AL-Ittefaq Textiles Limited

26 September 2023

Observations

Ferro-scanning: 2 rebar at short face

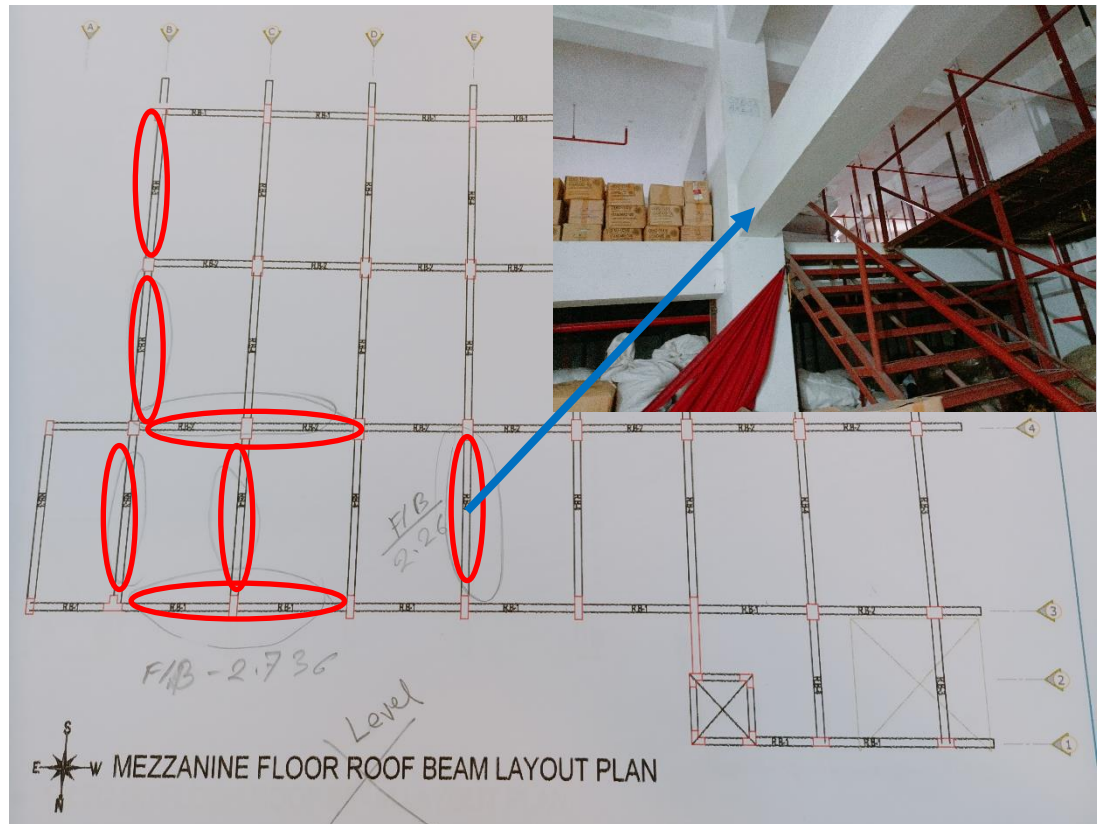
Marked beams are found at different level

Rebar at C-1 type column not matched with drawings. Two rebars were found at short face on 4th floor level instead of three. Moreover, some beams are found in different level at mezzanine level.

Building engineer is required to confirm the amount of rebar in column and update the drawing with connection details.

Column schedule: 3 rebar at short face

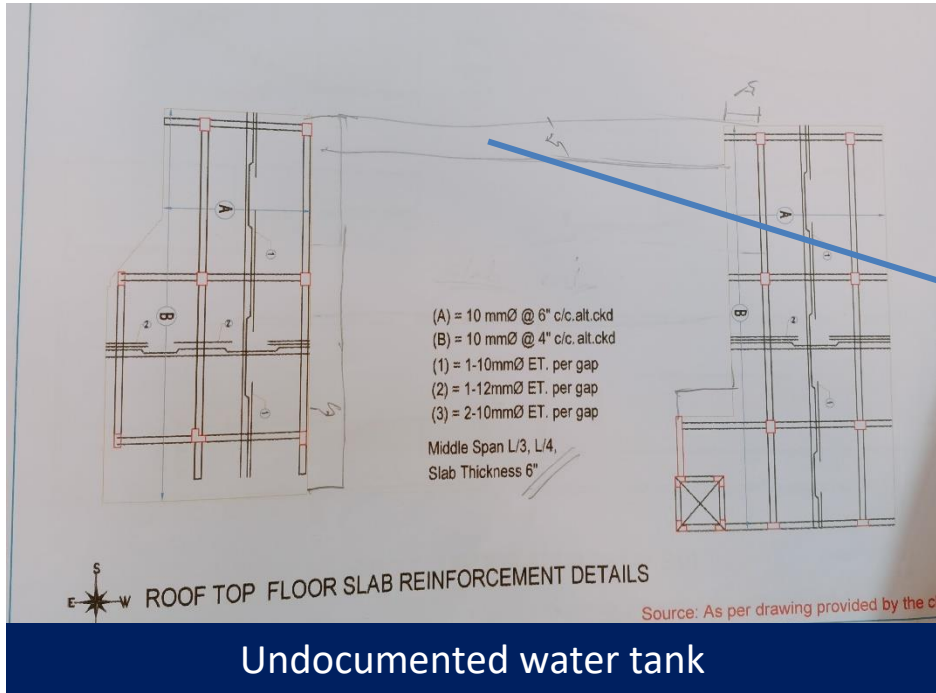
Undocumented walkway slab was found at the roof. Building engineer is required to confirm the amount of rebar in column and prepare accurate as-built structural drawing with necessary connection details.

1st floor load plan: finishing area with 3 kN/m² live load

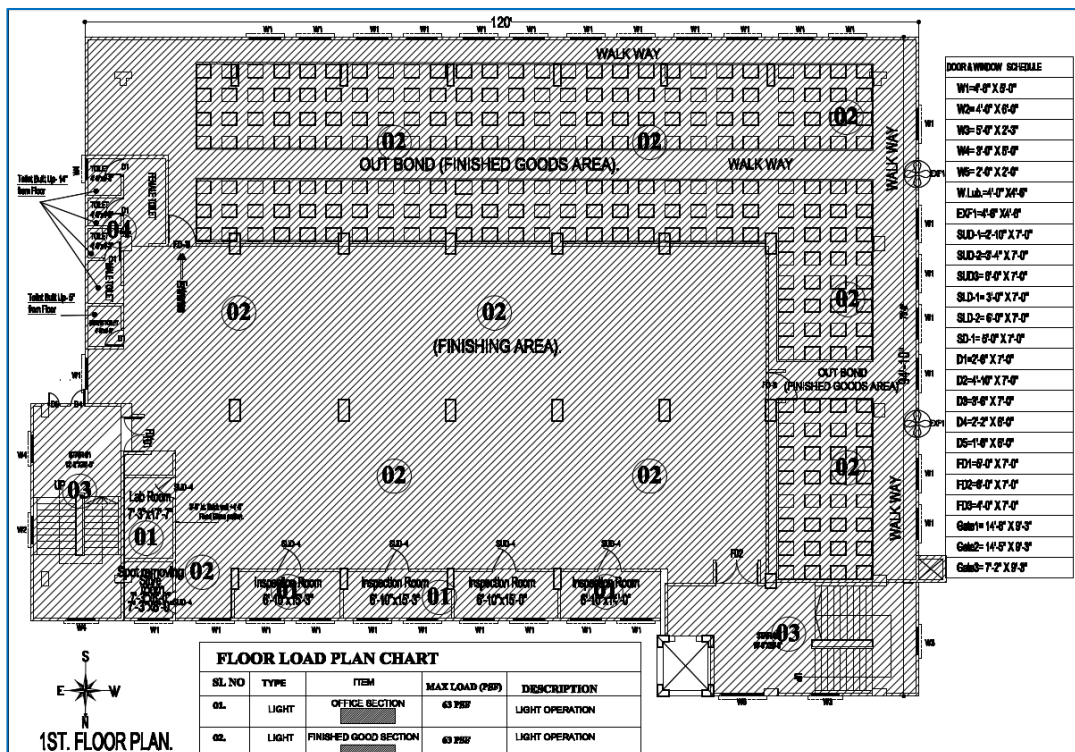
The first floor of the building is allotted for storage. As per BNBC, the minimum floor live load for storage is 6 kN/m² (126 psf). But the first floor of the building is designed for 3 kN/m² live loads.

Moreover, core cutting layout required was missing.

Factory engineer is required to revise the load plan and related design documents based on BNBC requirement.

Column and beams adjacent of driveway of loading unloading zone

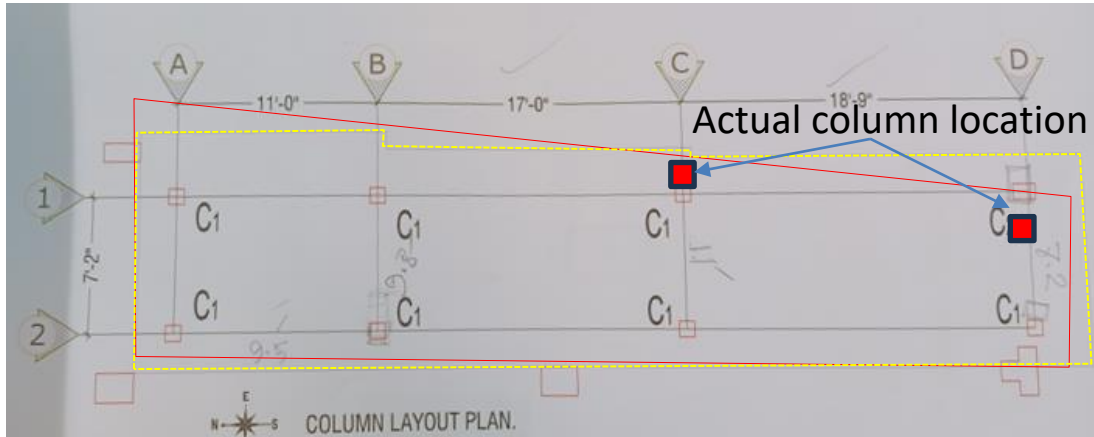
Column and beams adjacent to the driveway of loading unloading area is susceptible to vehicle impact. The building engineer is required to provide separate barrier and signage to avoid possible vehicle impact on column & beam.

As per drawing column & slab layout marked in yellow

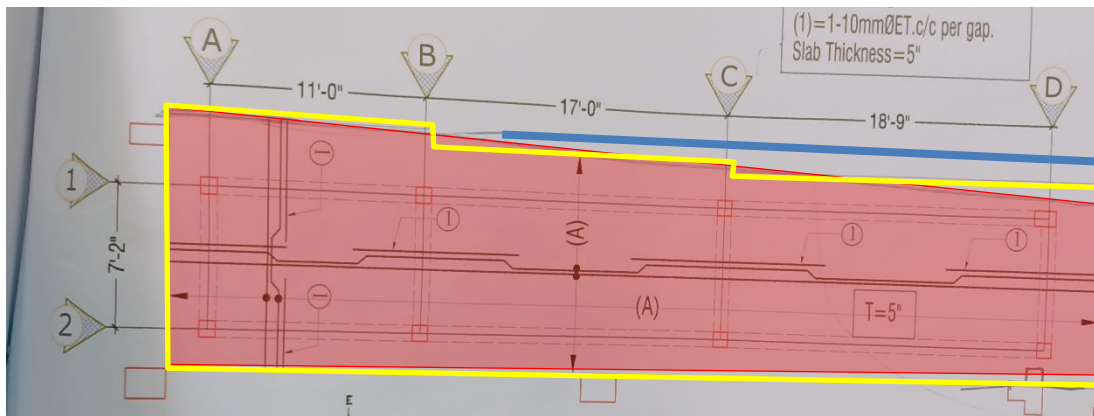
Grid dimension and slab layout did not match with as-built condition. Also, core cutting location has not been prepared and all core cutting location could not be verified. Building engineer is required to survey the structure and prepare accurate as-built drawings showing all structural details. Also, revise the design report based on as-built drawing and submit to RSC.

Actual slab layout mentioned in red
